UNITED STATES PATENT AND TRADEMARK OFFICE

Office Action Summary	Application No. 10/804,595	Applicant(s) RUBIE ET AL.	
	Examiner Cheryl Miller	Art Unit 3738

DETAILED ACTION

FIG. 9

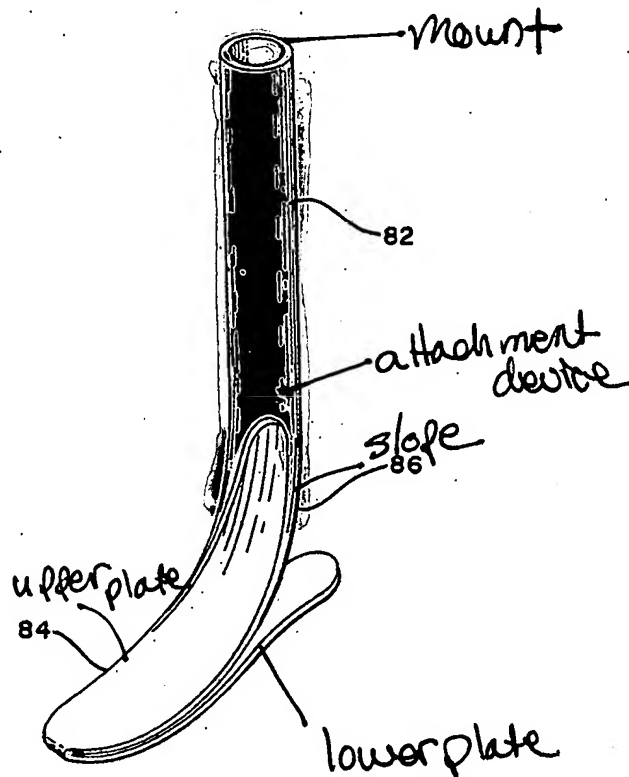
Referring to the second group of claims, Merlette discloses a lower leg prosthesis comprising a curved upper foot plate, a lower foot plate, and an attachment device (14; 82) coupled to the upper foot plate (16; 84), the device having a lower surface conforming to the slope of the upper foot plate (see attachment 1). Merlette discloses a mounting portion that is horizontal and wherein the attachment device is bonded to the upper plate (see fig.9). Merlette discloses an elastomeric layer between the two plates (see above).

Attachment #2 (marked up)

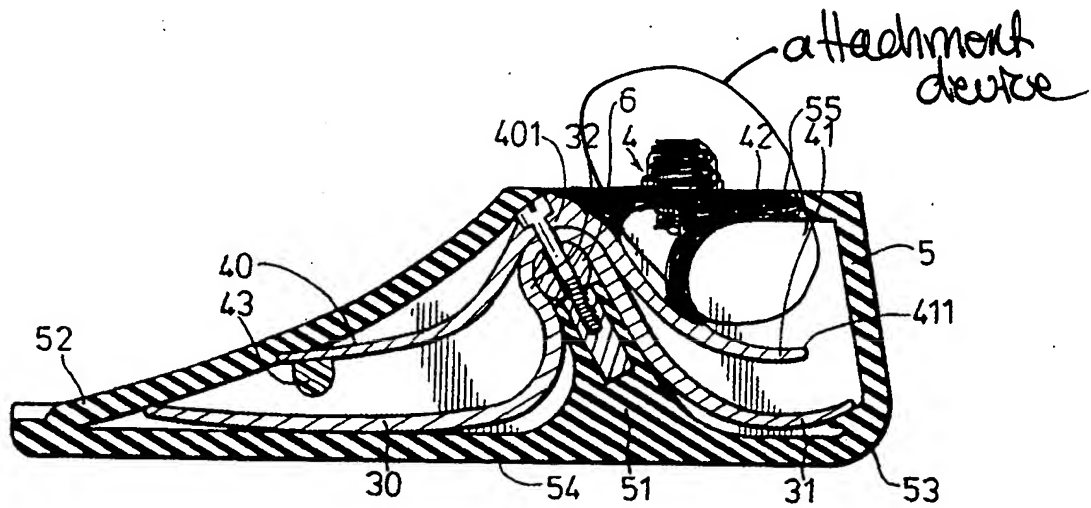
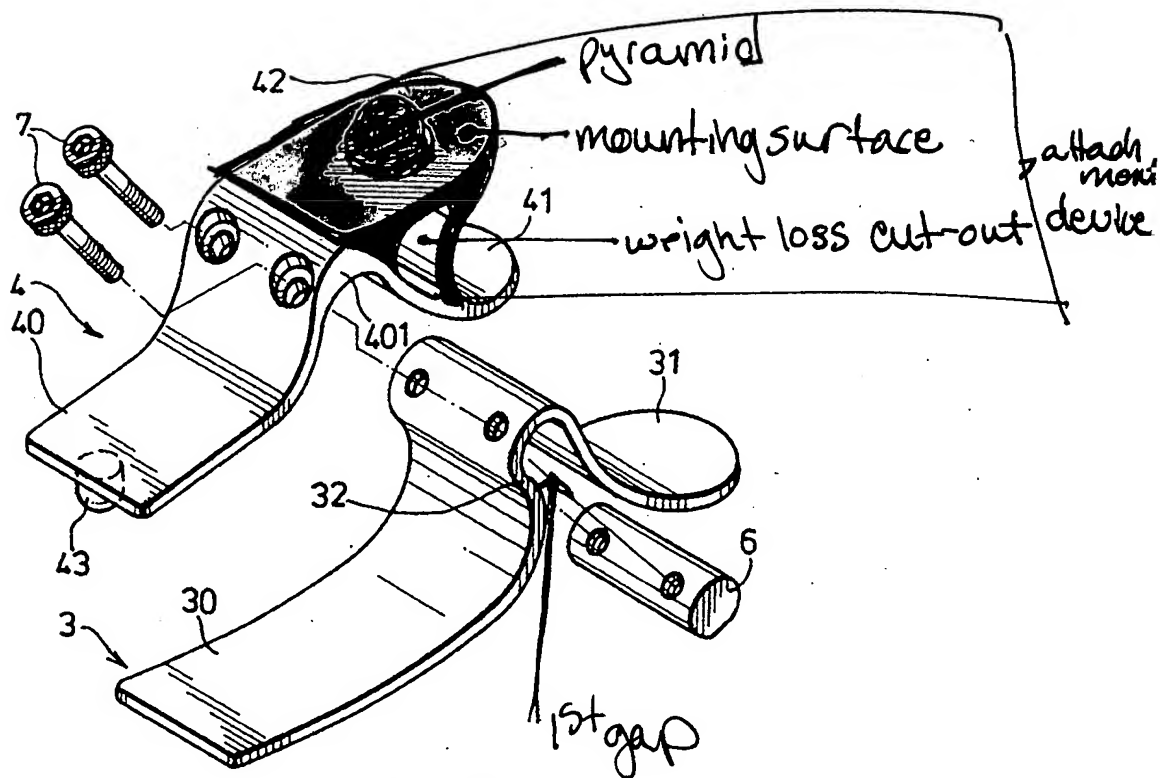
Claims 25-26, 28-33, 39, 40, 41, and 47-48 are rejected under 35 U.S.C. 102(b) as being anticipated by Chen (US 5,507,838). Chen discloses a lower leg prosthesis comprising a curved upper plate (40, 41), a lower plate (30, 31), and an attachment device (4; 42) coupled and conforming to the upper plate (see fig.4, 5). Chen discloses the attachment device to comprise a wedge shaped portion conforming to the upper plate, a horizontal mounting portion and a pyramid projection (see attachment 2). Chen discloses a weight reducing cutout in a forward

portion of the attachment device (see attachment 2; figs. 4, 5). Chen discloses a forefoot (30) and heel portion (31) being separated by a gap (near where 6 is located).
